# Staff Report – Board of Zoning Appeals

Docket #:	BZA2025-011 Development Standard Variance		
Applicant:	Westminster Village Greenwood, 295 Village Lane, Greenwood, IN 46143		
Owner:	Westminster Village Greenwood, 295 Village Lane, Greenwood, IN 46143		
Subject Property:	Subject Property: 295 Village Lane, Greenwood, IN 46143		
Staff Contact:	Gabe Nelson, nelsong@greenwood.in.gov, 317-887-5230

Exhibit C

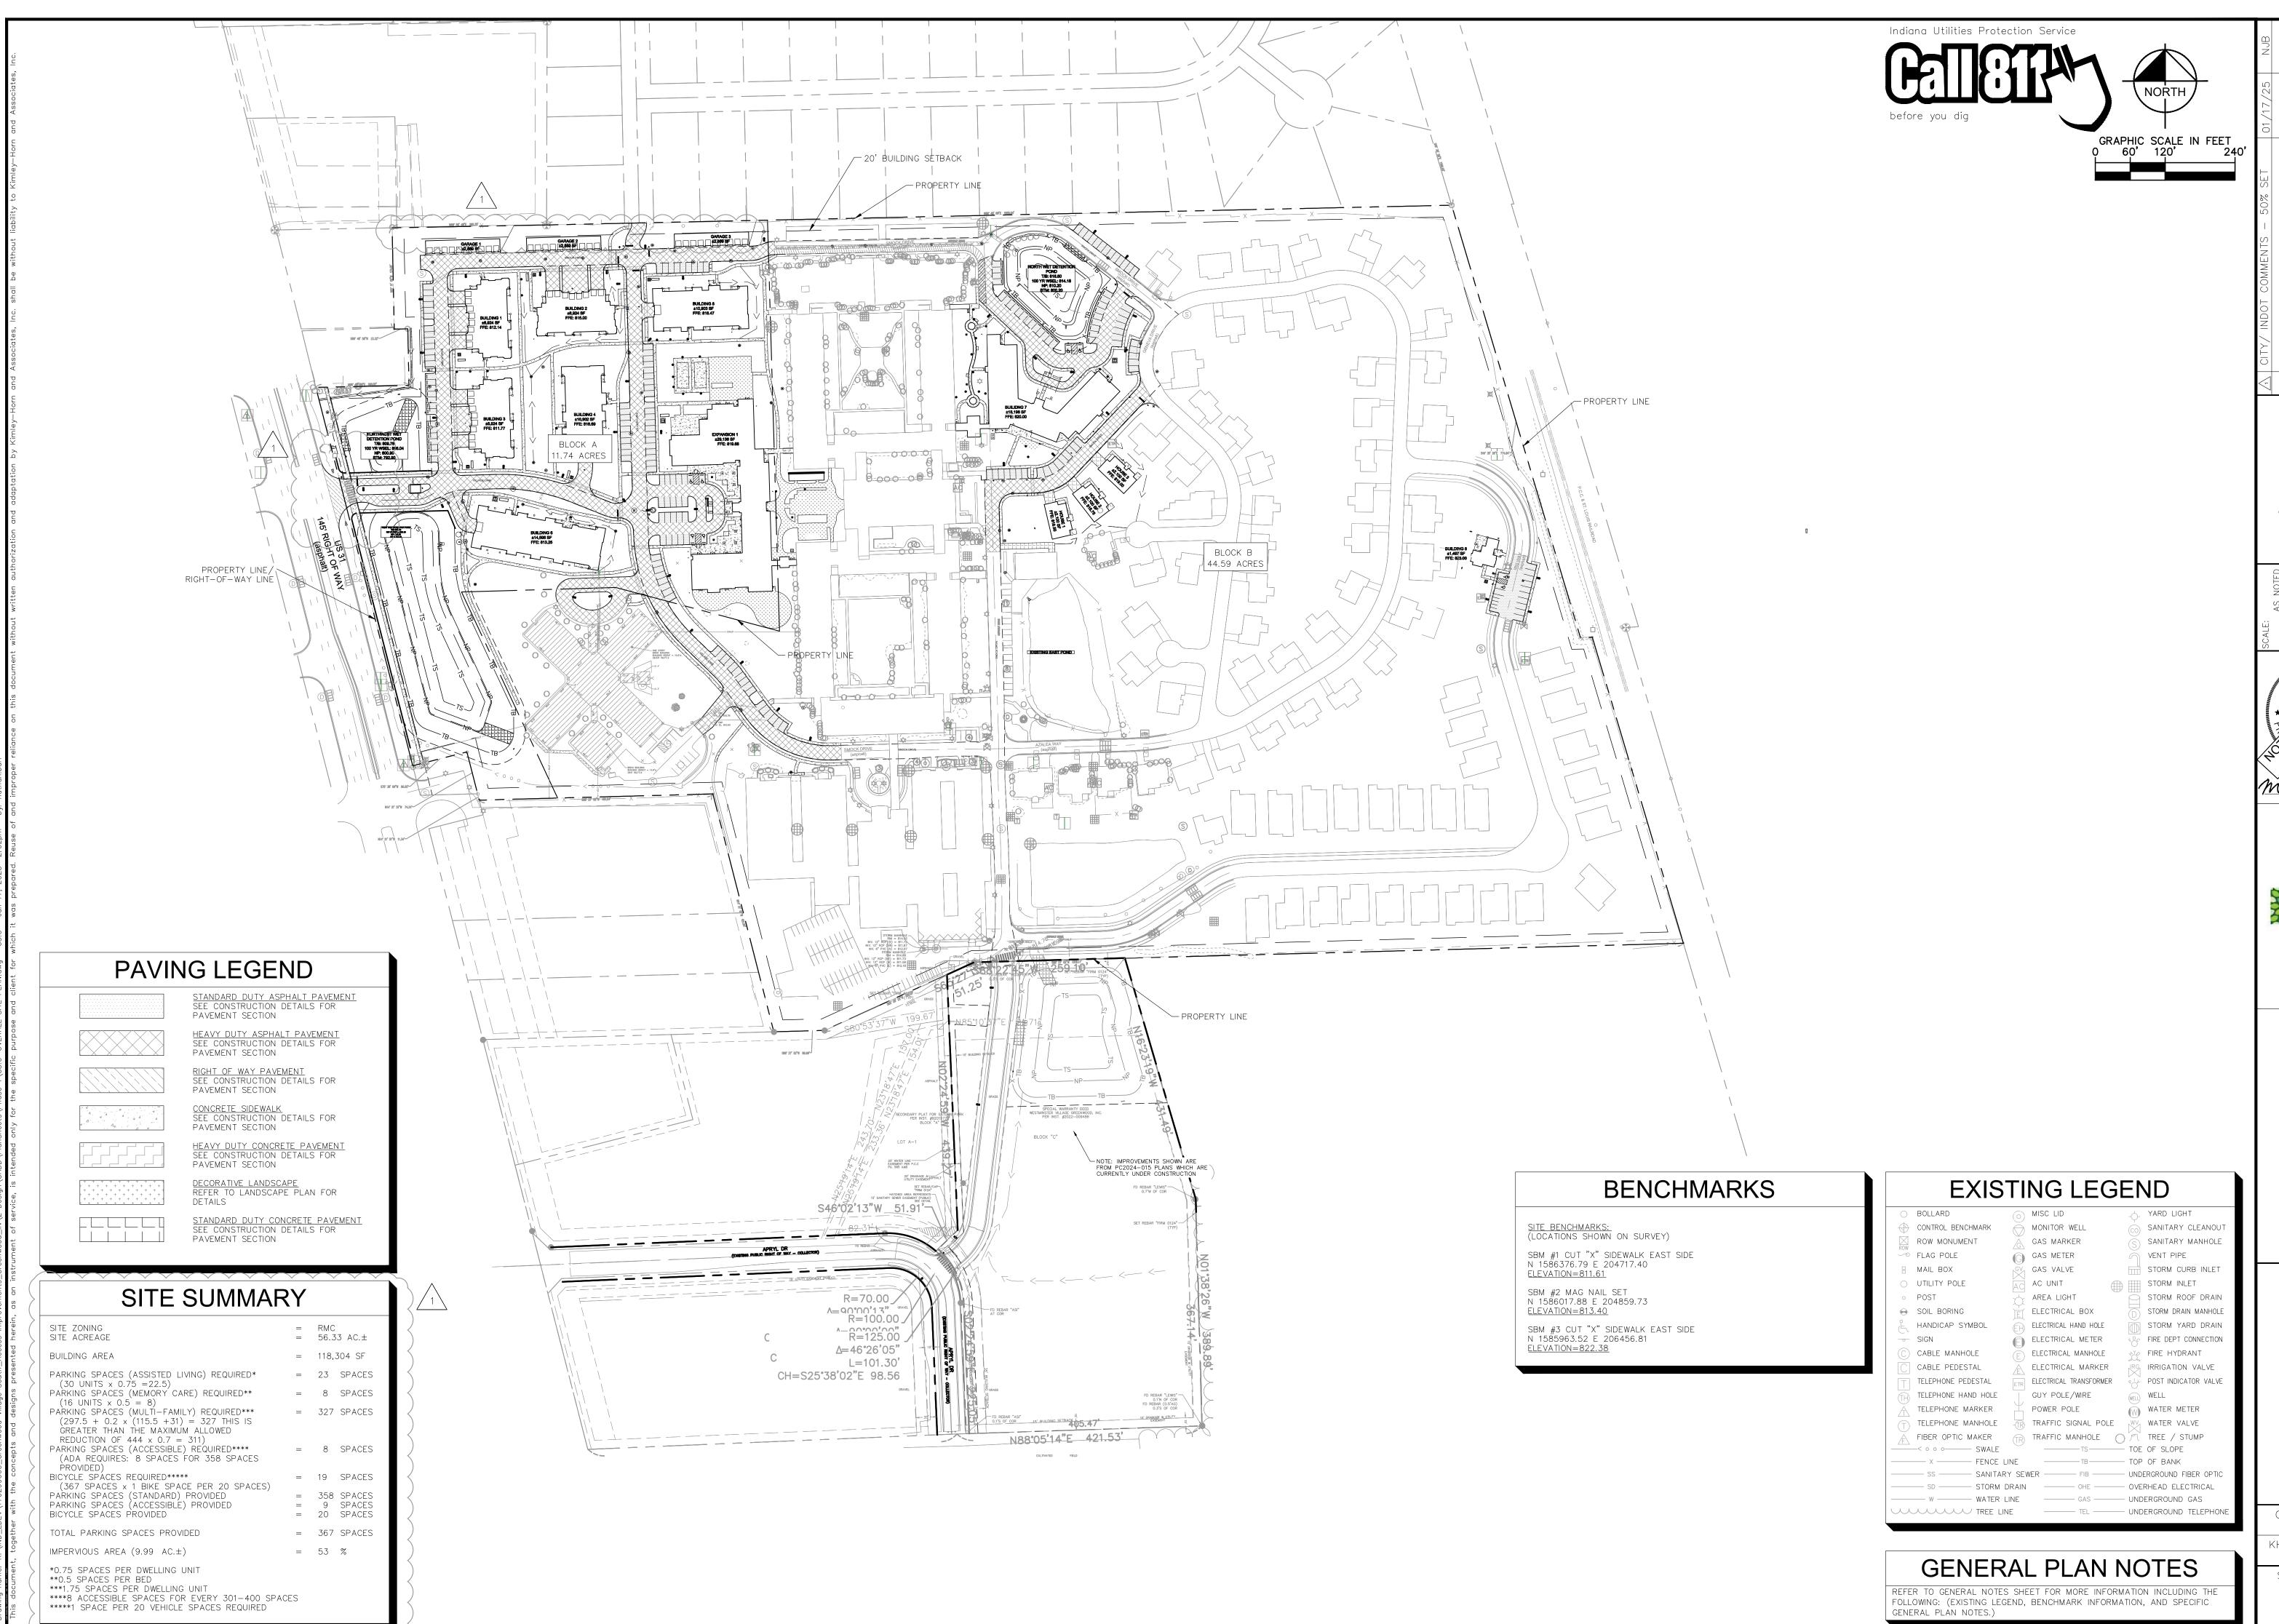
These requests apply to multiple proposed buildings across the Greenwood Village South Campus:

- Variances #1-5 shall apply to Buildings 1-8, Expansion 1, Houses 1-3, Garages 1-3, and the Guardhouse
- Variance #6 shall apply to Buildings 1-6, and Building 8
- Variance #7 shall apply to Buildings 4-6
